**TRANS/WP.15/AC.1/2002/1**  
**27 November 2001**

**Joint Meeting of the RID Safety Committee and the  
Working Party on the Transport of Dangerous Goods**  
(Bern, 18-22 March 2002)

**Sub-section 6.1.6.2: Revision of the "list of substances to which the standard liquids  
may be regarded as equivalents for the purposes of 6.1.5.2.6"**

**Transmitted by the Government of Germany \*/**

**Scheme for the assignment of substances, solutions and mixtures to standard liquids**

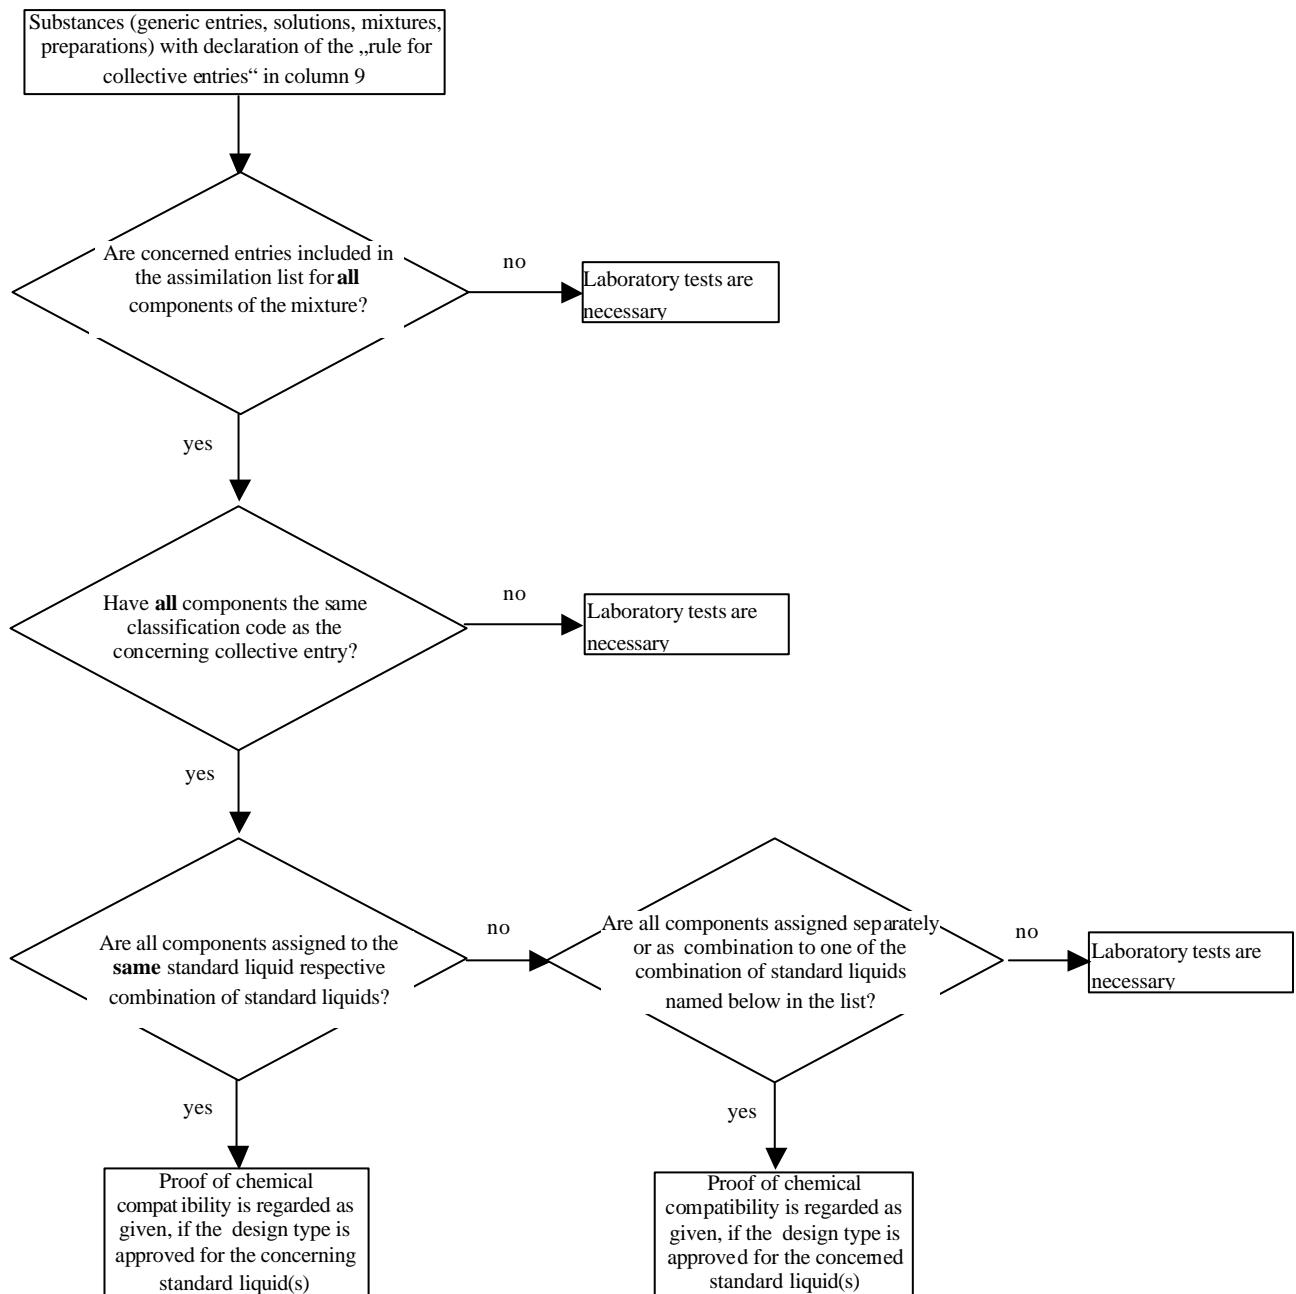
1. Some of the problems raised could be removed by editorial changes at this stage of the discussions.
2. The structural problems could be solved in the future adding new codes e.g. in column 9a of chapter 3.2 for each entry concerned.
3. The Joint Meeting could apply to a future standard (e.g. draft standard prCEN/ISO 16101 – compatibility testing for plastics packagings), which includes an appropriately structured assimilation list; the process of standardization could be controlled by the new working group of the Joint Meeting.
4. In both cases No 2 and 3 an additional rule for collective entries would be necessary as it was worked out in the German working group and as it is outlined below, either in the provisions or in the standard.
